5.2 Access From G08

Stepped Access

Above and Right. Amended design for stepped access from G08

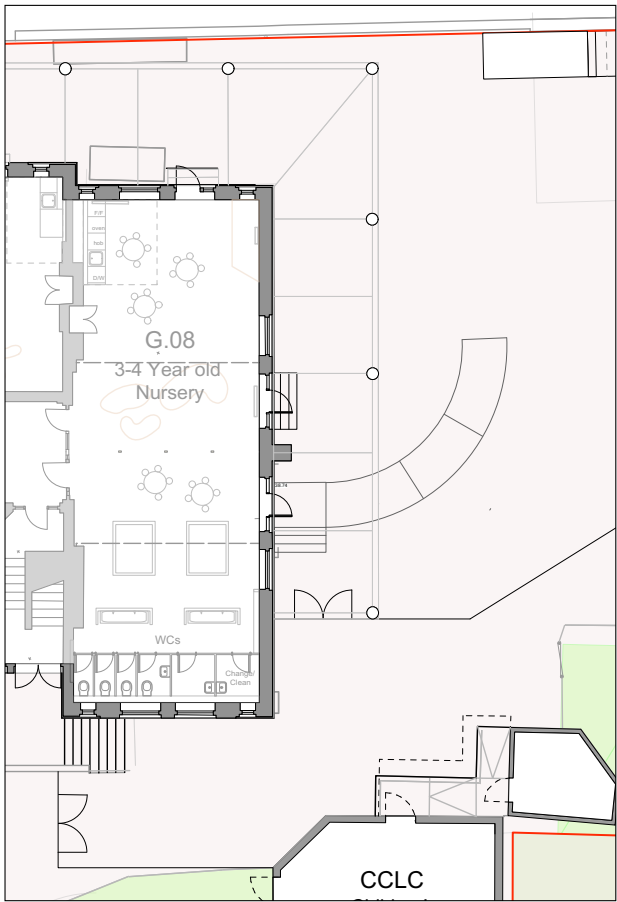
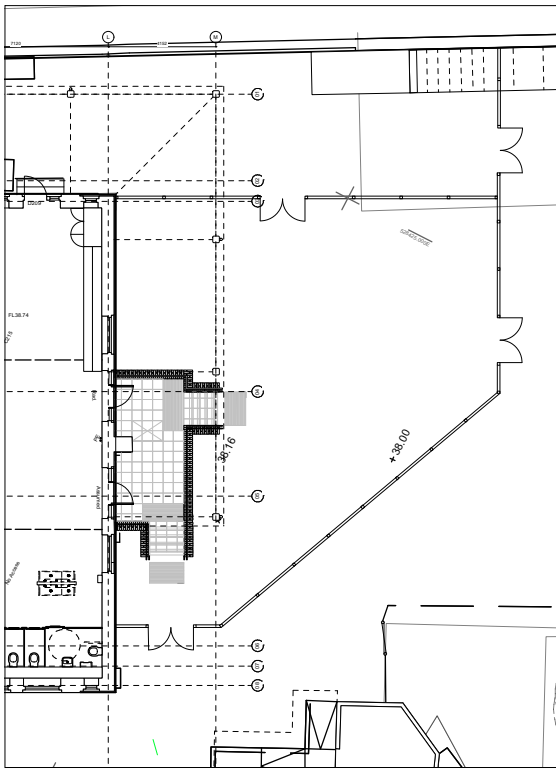
During the final stages of design development, the school client concluded that the provision of a new access ramp would not be desirable due to the large area of space it would take up within the now subdivided playground.

A series of ramp designs had been looked at in detail however the client group concluded that none of these were successful and would all inhibit the operation of daily activities.

Given the number of steps elsewhere in the building, the school is currently unable to accept pupils who are dependant on wheelchairs and the conclusion was to preserve usable playground space.

The alternative approach has been to provide a new set of steps with a generous landing designed for use by ambulant disabled users, featuring the following provisions of Part M and BS 8300:

- Unobstructed landings of not less than 1200mm
- Corduroy hazard warning surfaces at the top and bottom of each flight.
- Visually contrasting step nosings.
- Dual handrails on either side of the site to cater to younger users.
- Slip resistance of 36 PTV for level zones and 38.5 PTV and above for areas with a 2.5% gradient.
- Lighting to a minimum luminance of 100 lux from multiple sources to avoid strong shadows and excessive glare.
